TRANSMITTAL OF RESPONSES TO THE UNITED STATES ENVIRONMENTAL PROTECTION AGENCY AND OHIO ENVIRONMENTAL PROTECTION AGENCY COMMENTS ON THE 2001 SITE ENVIRONMENTAL REPORT

# RESPONSES TO U.S. EPA AND OEPA TECHNICAL REVIEW COMMENTS ON THE 2001 SITE ENVIRONMENTAL REPORT

# FERNALD ENVIRONMENTAL MANAGEMENT PROJECT FERNALD, OHIO

Figure 1. Forward Particle Tracks - VAM Zoomed Model Layer 12

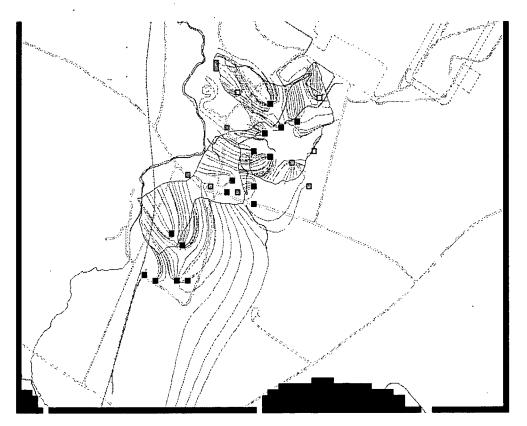
The text indicates that although a small portion of the plume perimeter lies outside of the observed capture zone, the entire plume lies within the 10-year, uranium-based footprint and will, therefore, be captured over the course of the remedy. This statement is misleading because the baseline remedy will likely never be implemented in its entirety and because particle tracking analysis of the current remedial pumping scenario as presented in the South Field Phase II Design Report indicate that complete capture will not be achieved. Figure 1 shows particle tracking results for VAM zoom model layer 12. Portions of the eastern flank of the South Plume are not being captured. Similar results were obtained for layers 11, 10, and 9. The particle tracking was performed by releasing particles along the perimeter of the 30 µg/L plume in each layer and tracking their movement given the flow field created by the proposed remedy. Although groundwater level monitoring data generally support capture of the plume and total uranium concentrations measured in the monitoring wells located east of the South Plume eastern boundary remain very low and show no upward trends, the modelderived capture zones do not indicate that complete capture of the plume is occurring for the current pumping scenario as presented in the South Field Phase II Design Report.

This comment is similar to Comment 11. Please refer to the response for Comment 11.

As stated in action to Comment 11.
